100G SR4 TxVEC Review

Comment r01-43

John Petrilla: Avago Technologies

September 2014

Consideration of Max and Min TxVEC Results

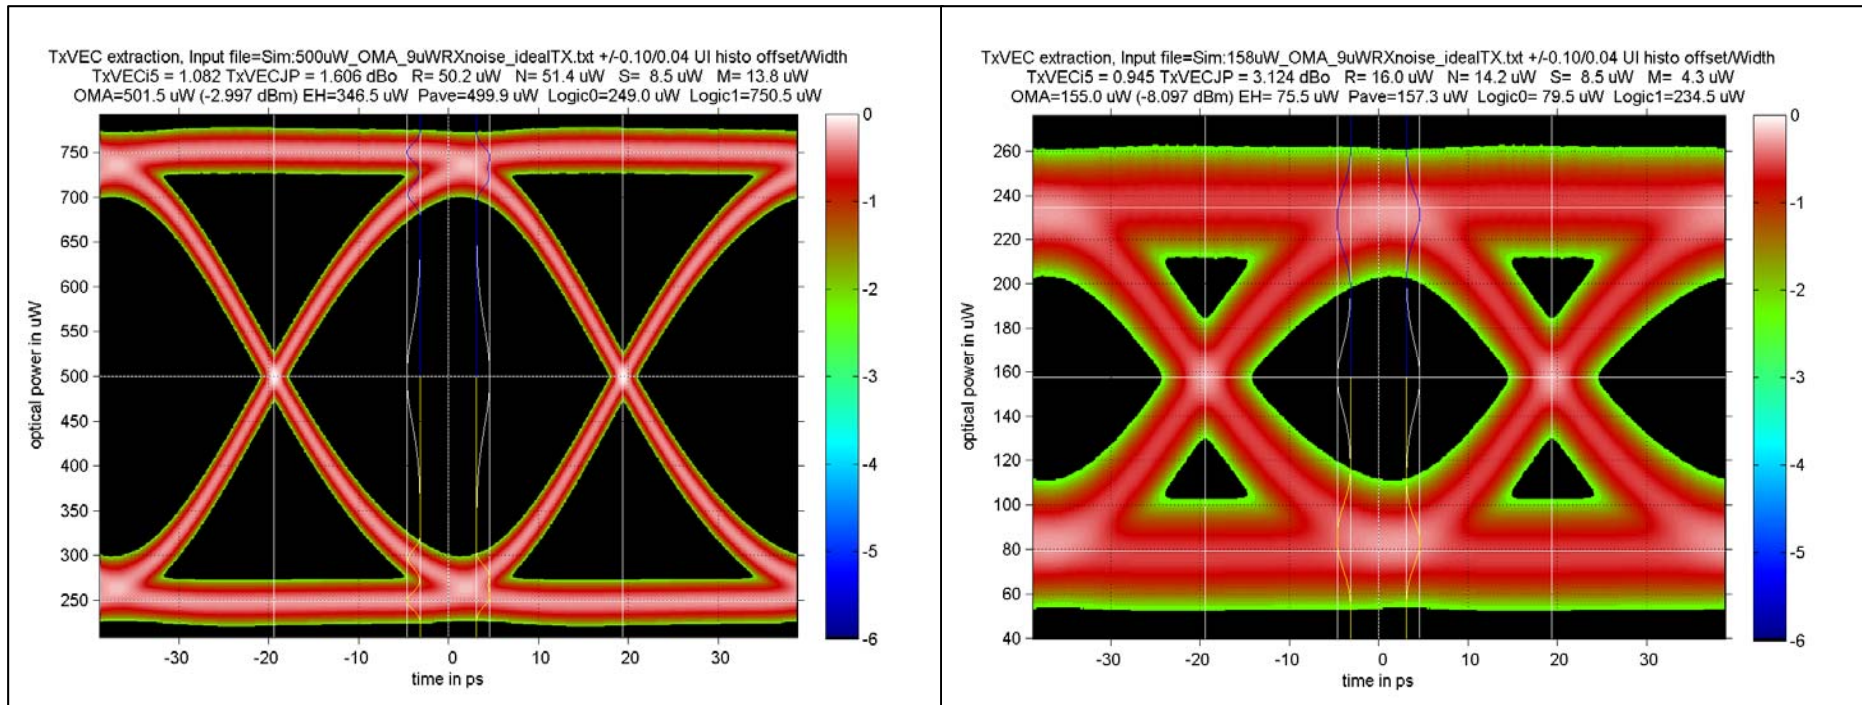
- Penalties included in the max TxVEC cases can amount to 4.86 dB to 5.17 dB depending on the inclusion of Pmn in the TxVEC calculation. Inclusion to Pmpn (not shown) can add another 0.1 dB to 0.2 dB to the Tx VEC calculation. **The max value for TxVEC should be 4.9 dB to 5.3 dB depending on the inclusion of Pmn & Pmpn.**

- The min expected value for TxVEC is expected to be 0.8 to 1.1 dB depending on the inclusion of Pmn and Pmpn.

TxVEC Simulations

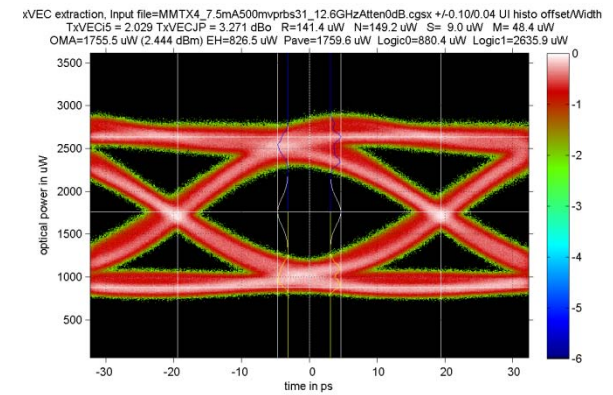
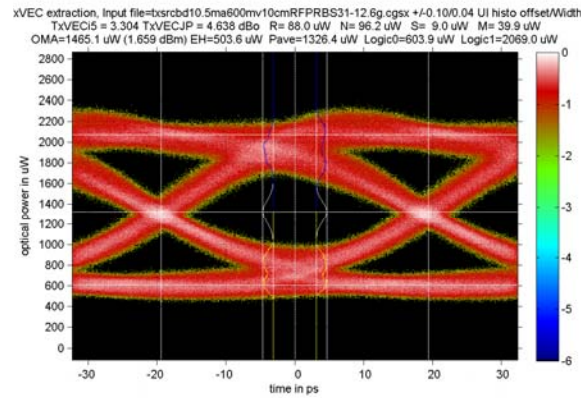
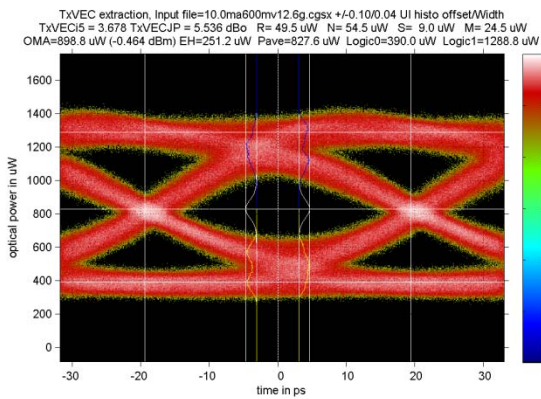
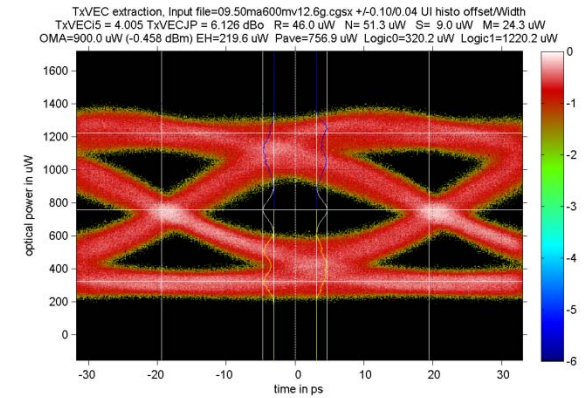
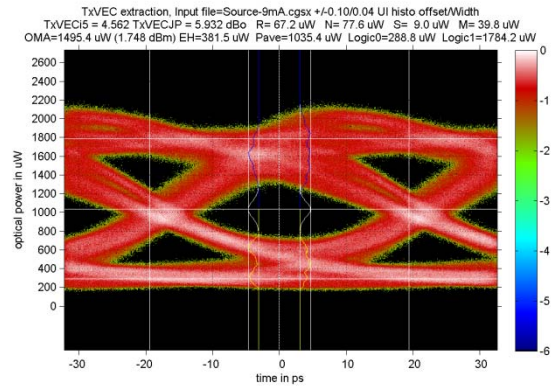
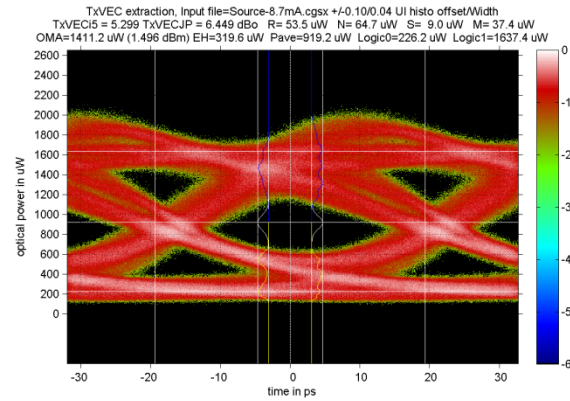
- Simulation results are shown above for two different Tx output signal levels, -3.0 dBm and -8.1 dBm, as observed after a 12.6 GHz LPF with 8.5 uW additive noise.
- Note the TxVEC result for this ideal Tx is relatively unaffected by the scope noise. This is a significant benefit of the TxVEC method.
- Also note that the TxVEC result for this ideal Tx is ~ 1.0 dB.

Tx Eyes and TxVEC Results with 12.6 GHz, 9uW Plug-in (2)

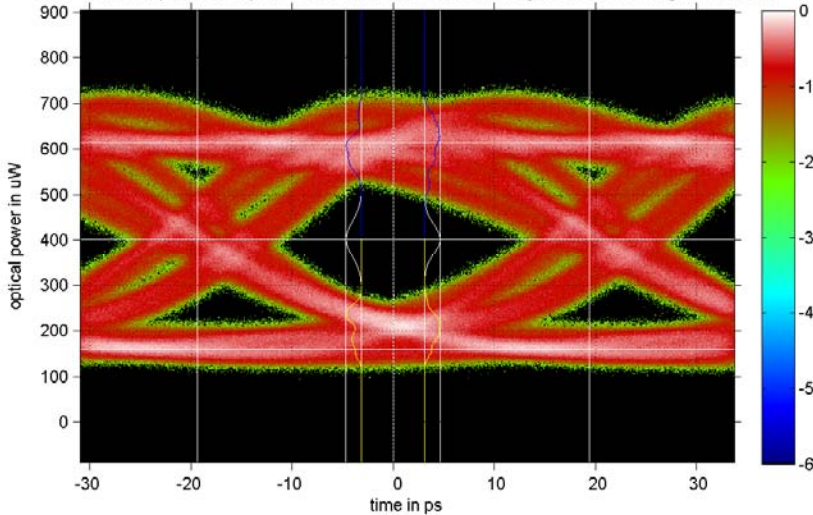
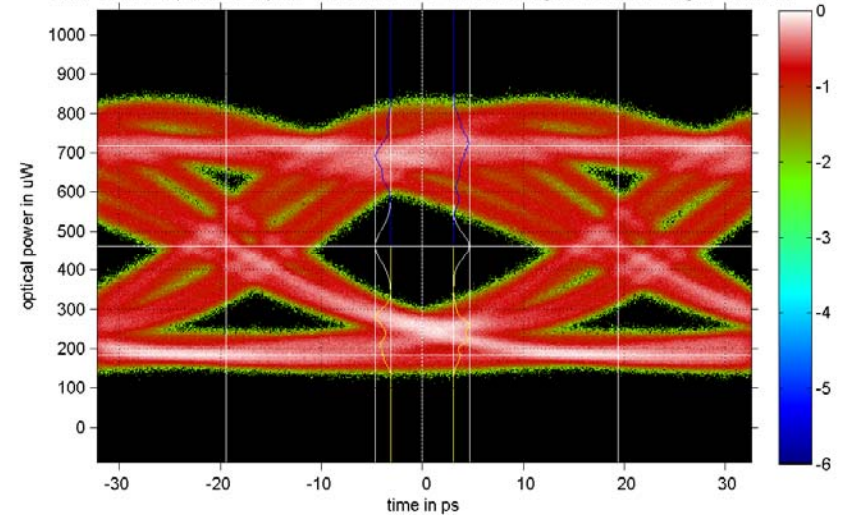
- These charts show eyes and TxVEC results for a TxVEC = 2.78 dB Tx and a TxVEC = 3.77 dB Tx.
- Here modest amounts of equalization were used to yield better eye openings.

BER with a TxVEC=4.56/5.30 dB Tx & 100 m of OM4

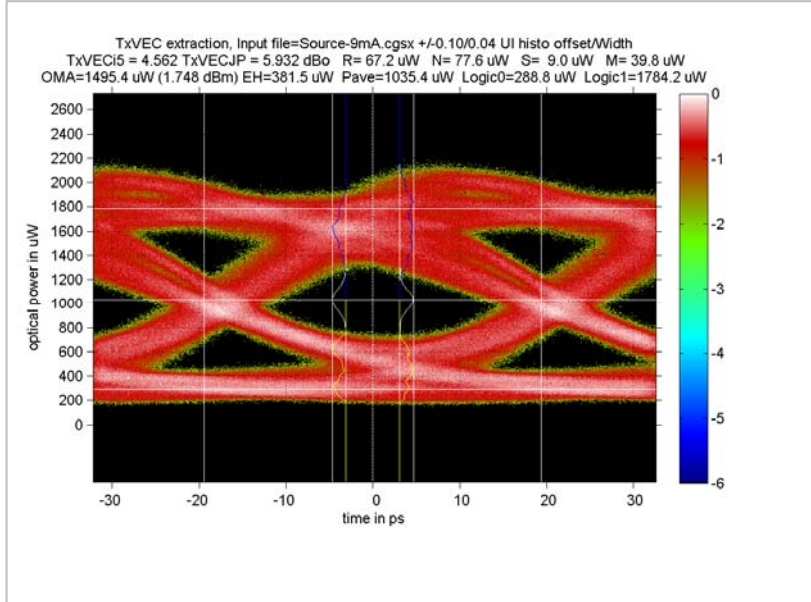
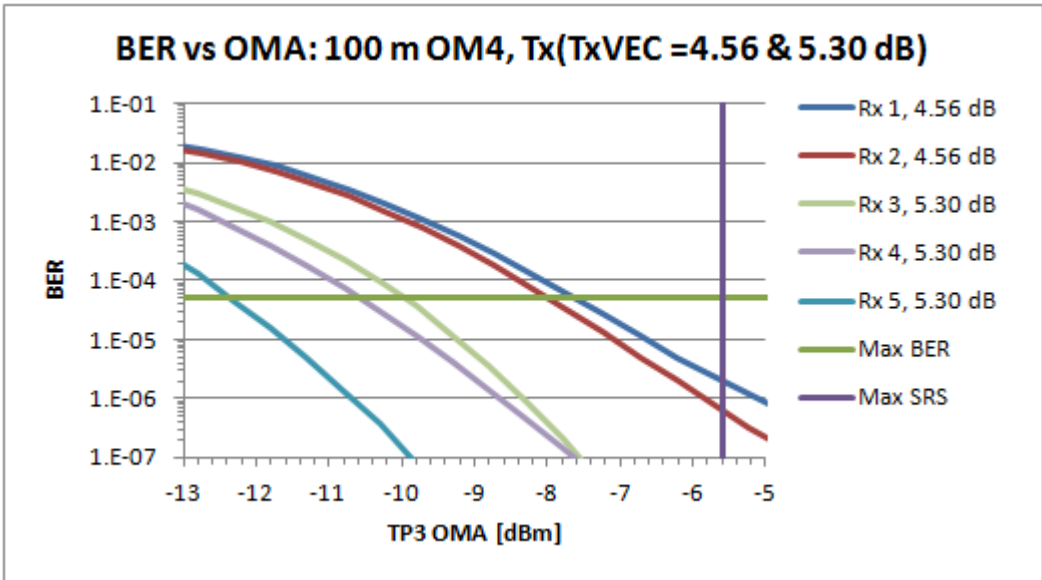
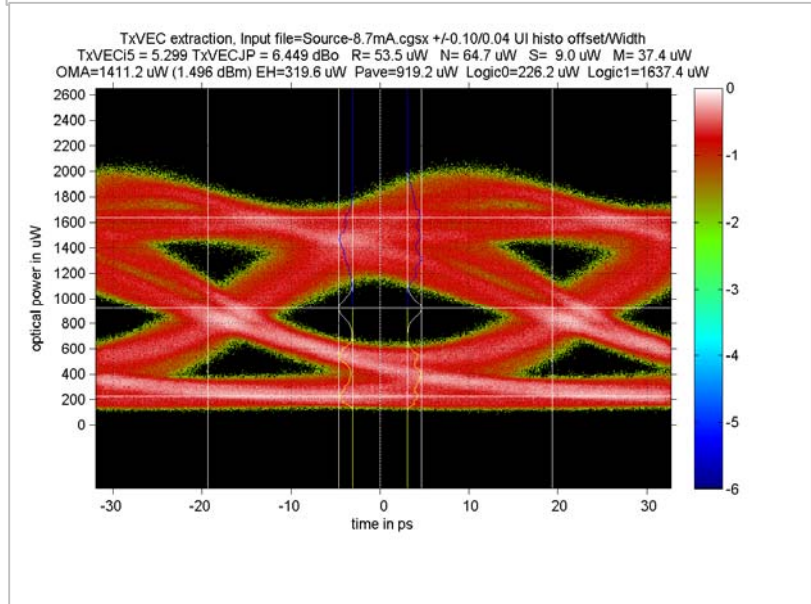
•The charts show a BER plot and the eyes and TxVEC characteristics for the transmitters used for the BER plot. Here TxVEC= 4.56 dB for one and 5.30 dB for the other. A worst case 100 m OM4 fiber (actually 110 m of 5023 MHzkm EBW OM4) was used to connect the Tx and Rx along with breakout jumpers and VOA. **These results indicate that a 100 m OM4 link can operate using a Tx with a TxVEC = 5 dB.**
